N7951A-02

Modification Recommended Service Note

N7951A – Advanced Power System, Dynamic DC Power Supply, 20V, 50A, 1000W

The Problem – Charge Present on the AC terminal when unplugging the unit.

Figure 12

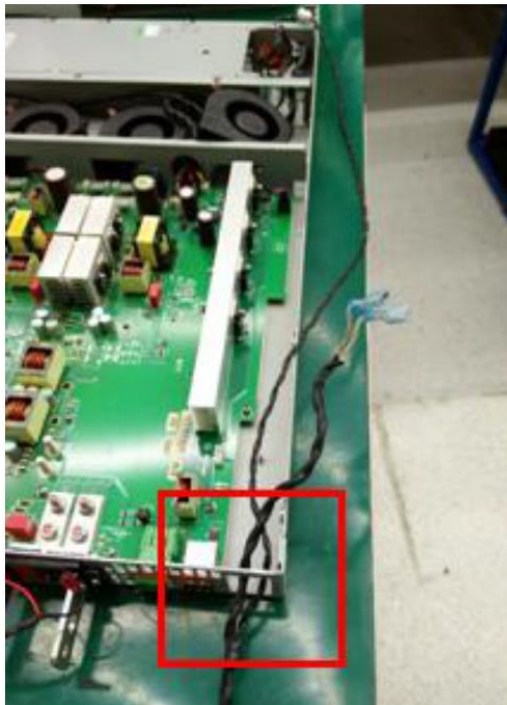
A charge is present on the AC terminal when unplugging the unit and the switch is off. Input capacitor of 0.47pF will store a charge above compliance limit A for normal operating condition at 230Vac input, however non-hazardous since the charge is < compliance limit B for single fault condition. This does not meet the requirements of IEC61010-1.

New AC line filter (5190-4495) with 15GENG3E-R is used to replace the existing AC line filter to optimize the discharge time.

12. Insert the AC line cable (5190-4495) into chassis as shown in

Figure 15

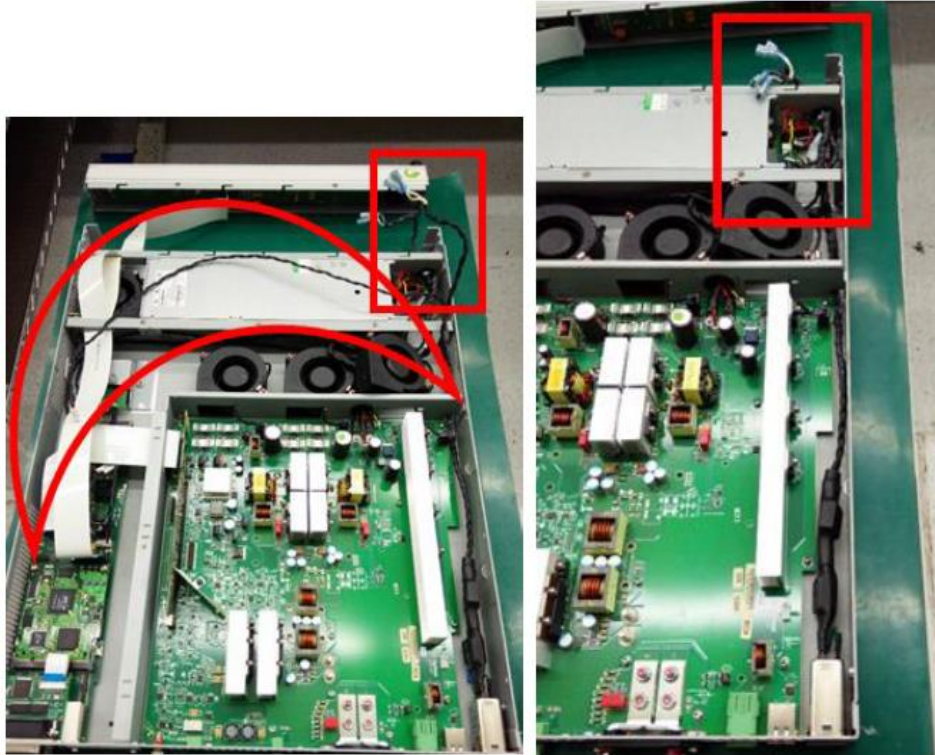
16. Route AC line through chassis hole until front panel. Another AC line cable will be insert into constellation PCA as shown Figure 15.

Figure 16

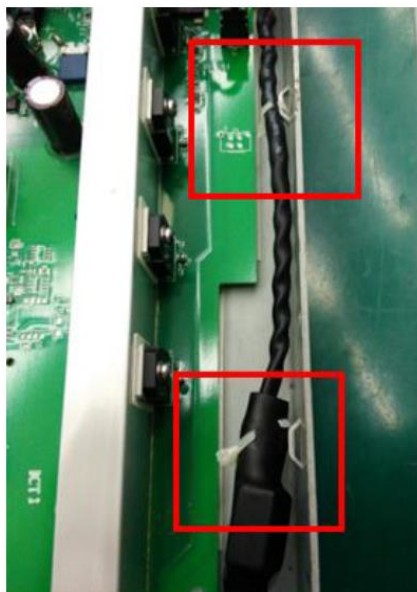
17. Insert 2 cable ties (1400-3204) to secure the AC line cable as shown in Figure 16.
